Technical Service Bulletin no. 29

Created by: Lab.gruppen AB Service Department

Date: 20121124

Reference no: C-X

Instruction concerning A104d- P34001Revision "E"

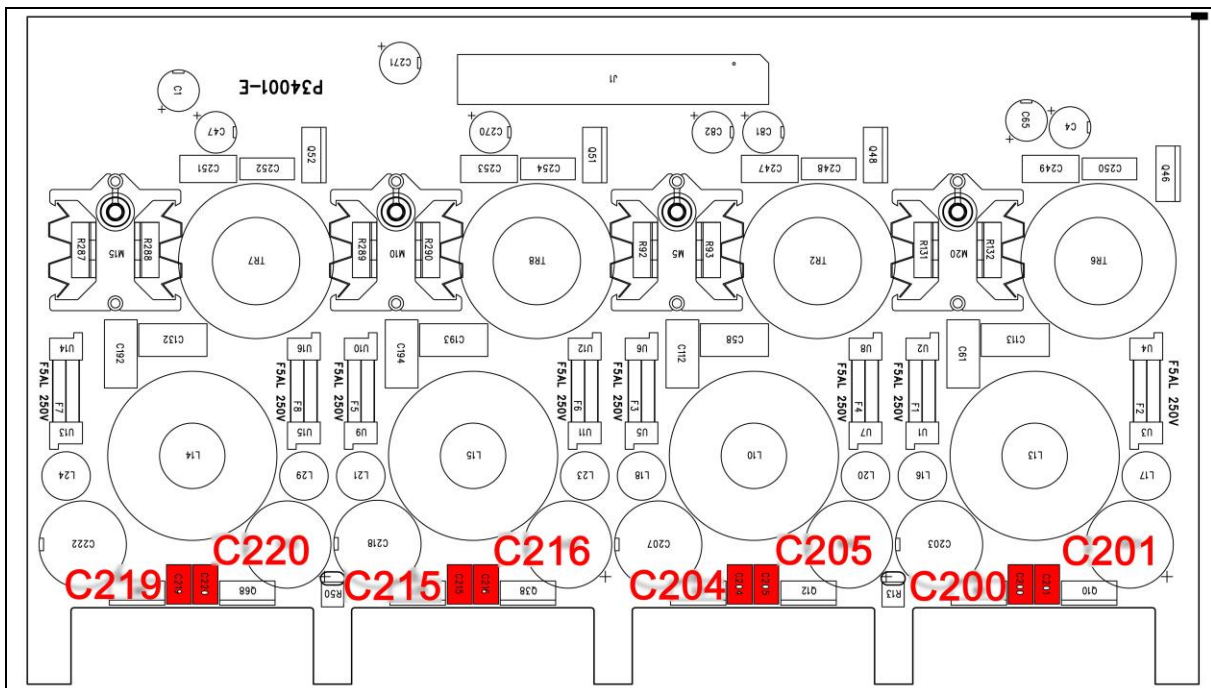
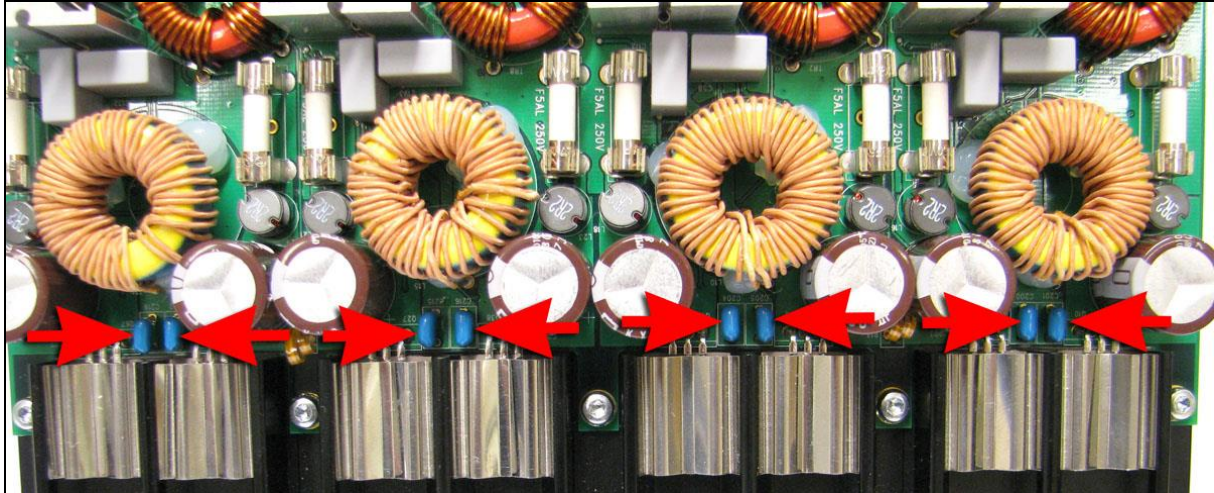
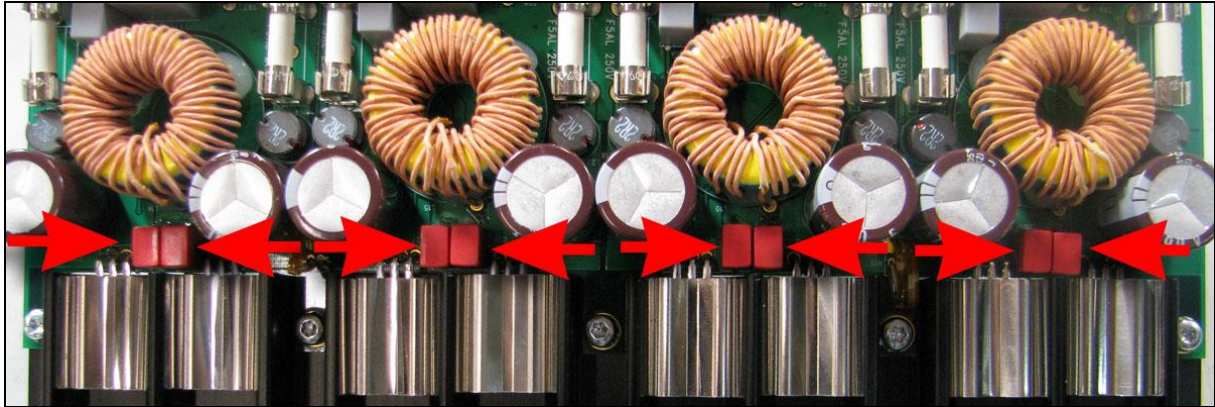
Remove capacitors C200-201, C204-205, C215-216 & C219-220.

Replace it with 0,1u 250V

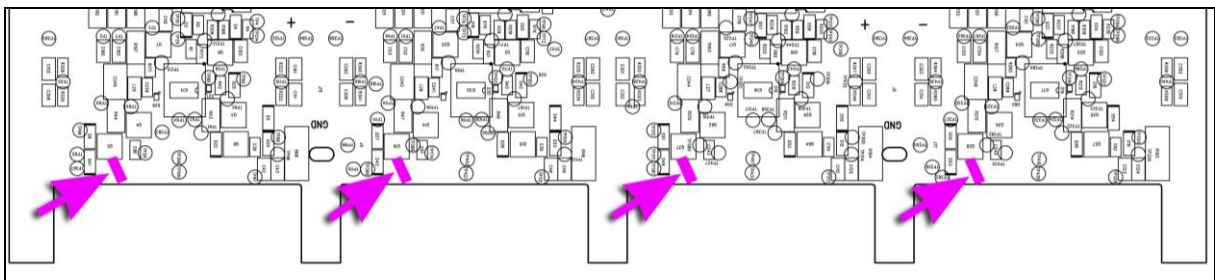
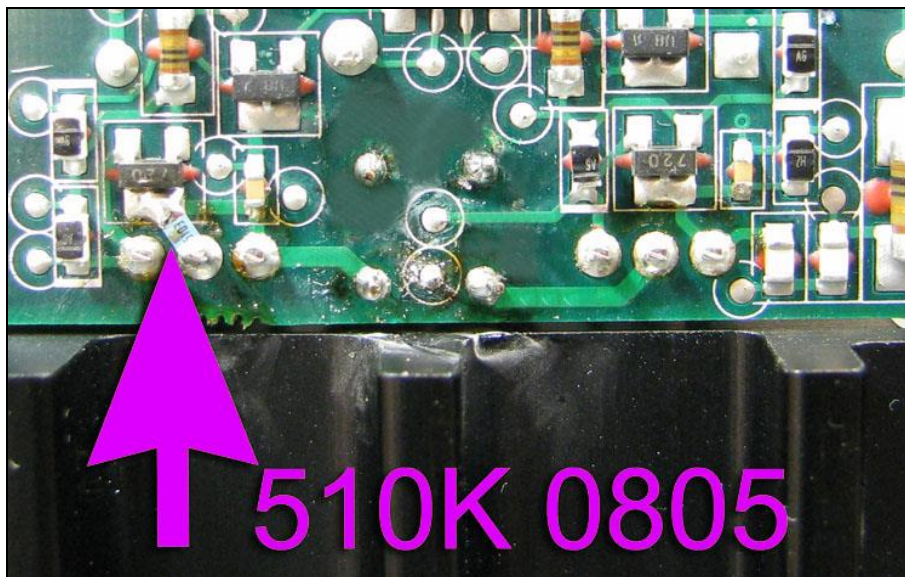
Mount & solder 510K 0805 resistors at all channels according to picture.
